# Access Compliance Report

## Public Rights-of-Way (Curb Ramps)

Intersection ID: 53416	Main Street: WAVERLY_CENTER_DR	Cross Street: SOUTHGROVE_ST	Location: NE
ADA ID: 18CB5A96CA04	Ramp Type: Perp	Initial Pass/Fail: Fail	Overall Compliance: No
Severity Score: 25			
Codes/Mitigation Info/Possible Solution		Field Measurements/Component Compliance

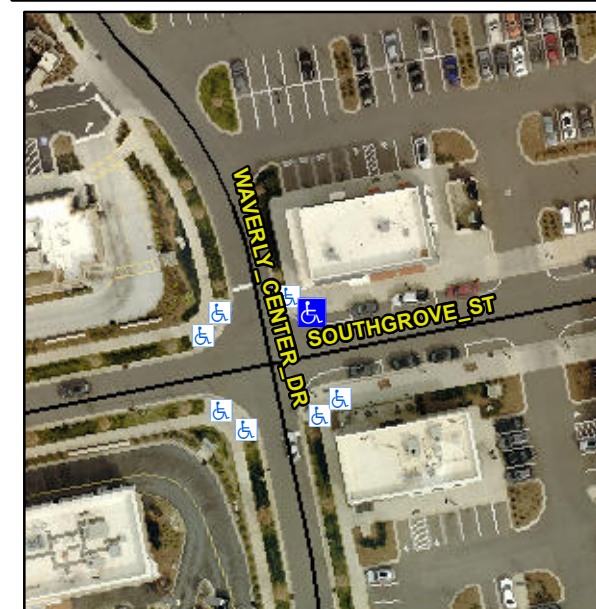
Compliance	Description	Data	Compliance	Description	Data
N/A	Ramp Length (in)	61.0	No	Ramp Slope (%)	12.8
Yes	Ramp Width (in)	48.0	Yes	Ramp XSlope (%)	0.2
N/A	Flare Type LT	N/A	N/A	Flare Type RT	N/A
N/A	Flare Slope LT (%)	N/A	N/A	Flare Slope RT (%)	N/A
N/A	Flare Traversable LT?	N/A	N/A	Flare Traversable RT?	N/A
N/A	Landing Length (in)	N/A	N/A	DWS Provided?	N/A
N/A	Landing Width (in)	N/A	N/A	DWS Contrast?	N/A
N/A	Landing Slope (%)	N/A	N/A	DWS Length (in)	N/A
N/A	Landing X Slope (%)	N/A	N/A	DWS Full Width?	N/A
N/A	Landing Curb? (Y/N)	N/A	N/A	DWS Offset (in)	N/A
N/A	Shared Landing?	N/A			
N/A	Gutter Ponding?	N/A	N/A	Gutter Slope (%)	N/A
N/A	Gutter Lip Ht (in)	N/A	N/A	Gutter X Slope (%)	N/A
N/A	Painted X Walk1?	No	N/A	Painted X Walk2?	N/A
	X Walk 1 Direction	To S		X Walk 2 Direction	N/A
N/A	X Walk 1 Width (in)	N/A	N/A	X Walk 2 Width (in)	N/A
	X Walk 1 Slope (%)	1.8		X Walk 2 Slope (%)	N/A
	X Walk 1 X Slope (%)	0.5		X Walk 2 X Slope (%)	N/A

**Remove & Replace Entire Ramp.**
